# ZRD1/CCD1 Response Form

House No(s) 2461

Street Name Broadway

Enter short description of Technical Topic (5 words or less): Cantilever Window Openings

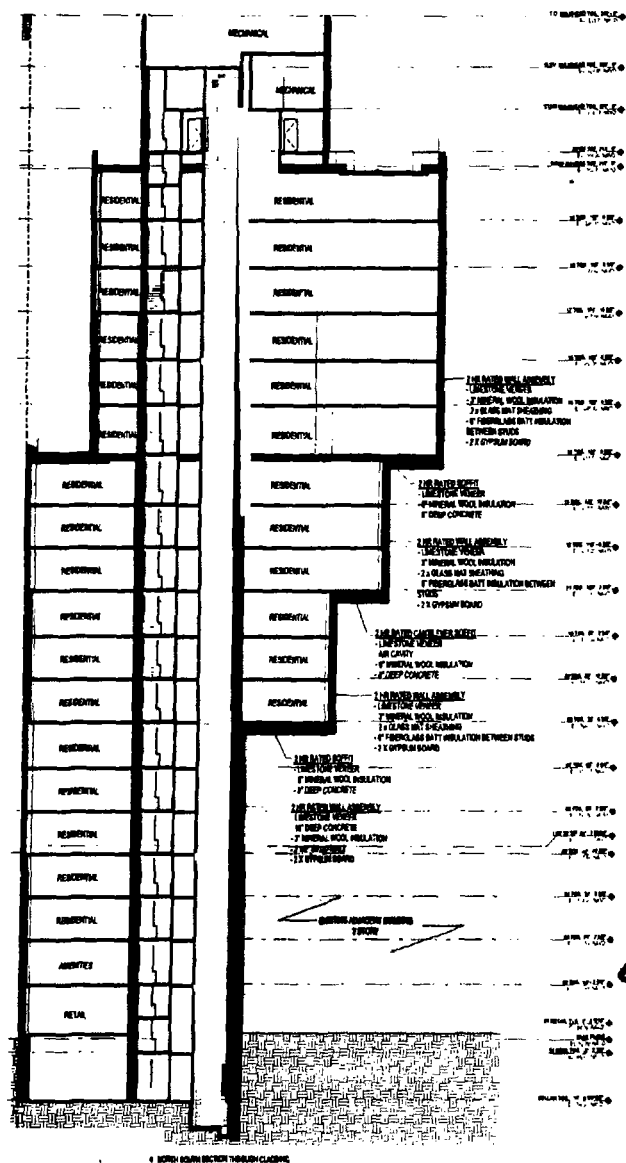
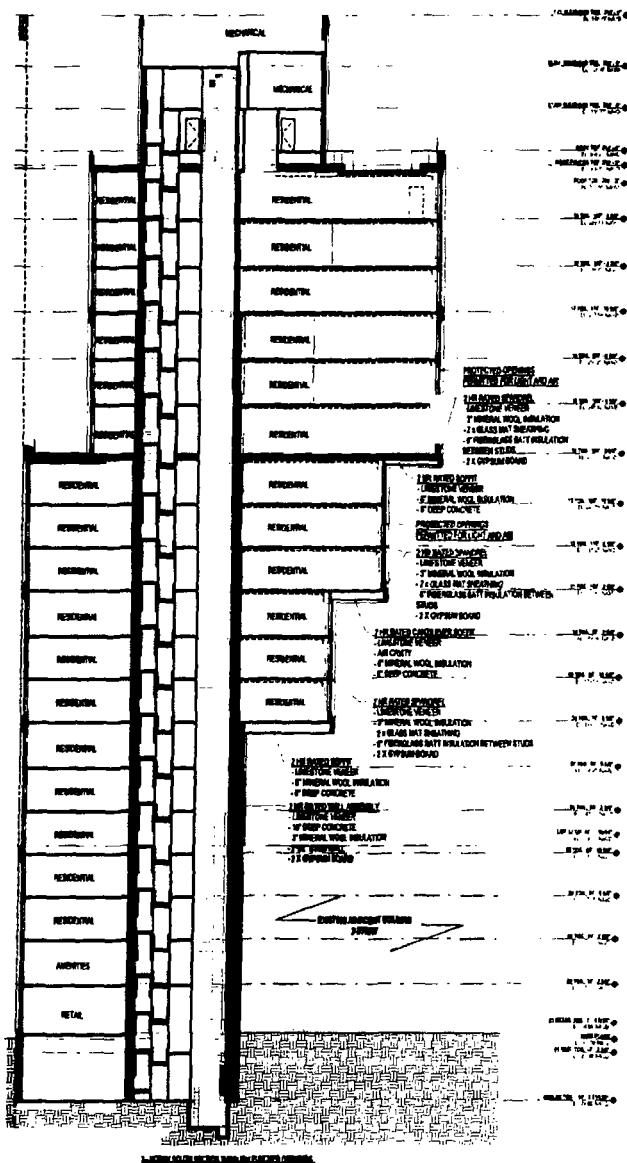
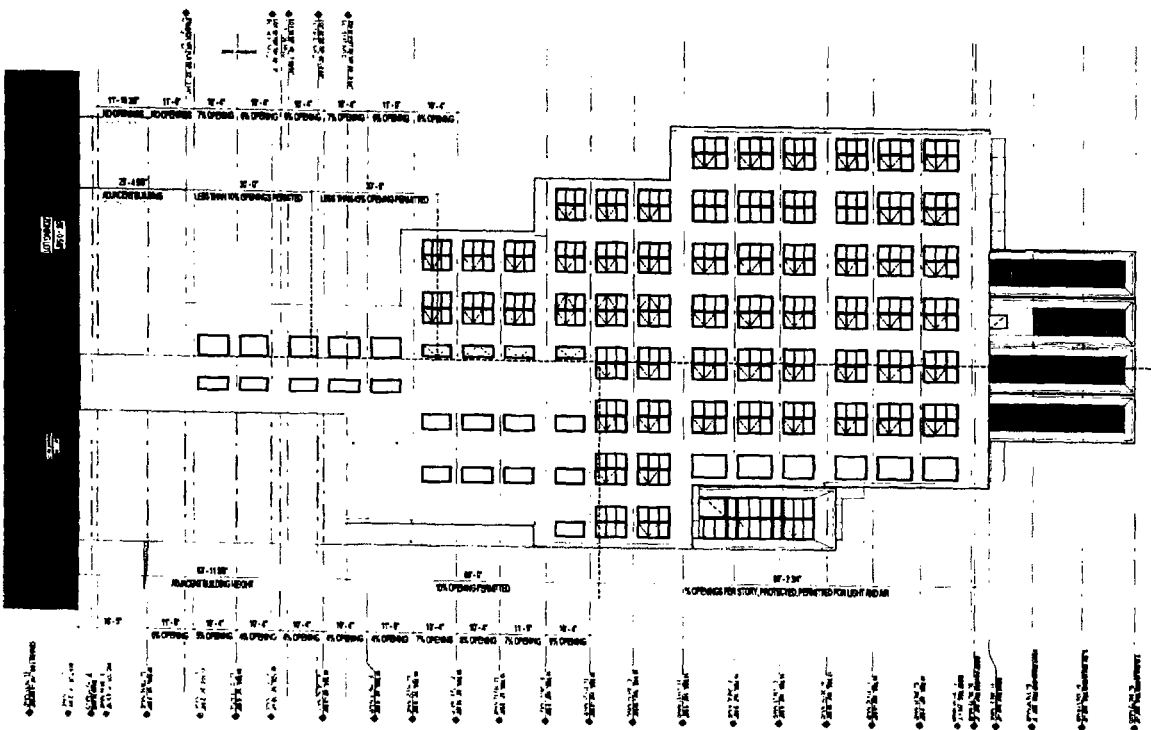
-The openings in the fire rated walls within 0'-0" to 30'-0" to the highest roof construction of the adjacent building, vary from no openings to more than the 10% permitted;

In order to achieve adequate light and air for the dwelling units proposed, there is a practical difficulty in limiting the openings to 10% (for windows located more than 30 feet above the adjacent roof, but less than 30 feet above the bulkheads on that roof). We are proposing that these openings be permitted up to 45% per floor. These windows are physically located more than 30 feet from the highest construction of the adjacent building (the bulkheads), and these windows are also located more than 30 feet, vertically, above the roof of the adjacent building.

-The underside of the cantilevered portion for the new building proposed at 2461 Broadway, shall be located ~26'-7.5" (at the eighth floor) above the existing roof of 2465 Broadway. The ~26'-7.5" accommodates the required 9'-0" FDNY access clearance as per FC 504.4.4.

-The cantilever will project over the adjacent building 25'-0" (Ranging from 18'-4" to 25'-0") at the eighth floor. There shall be no legal windows opening to the underside of the cantilever below (at the 7th floor).

-The cantilever will project over the adjacent building an additional 12'-6" at the eleventh floor. The depth of the rooms below the cantilever (located at the 10th floor), along with the depth of the cantilever, shall be within the maximum permitted 30 feet, as permitted by BC 1203.4.1.2.4.

-The cantilever will project over the adjacent building an additional 12'-6" at the fourteenth floor. The depth of the rooms below the cantilever (located at the 13th floor), along with the depth of the cantilever, shall be within the maximum permitted 30 feet, as permitted by BC 1203.4.1.2.4.

The request to review and deem acceptable the proposed window openings along the cantilever is hereby approved per the following conditions.

1. Provide protected window openings per BC 705.8.2
2. Comply with BB2015-17 VI.B
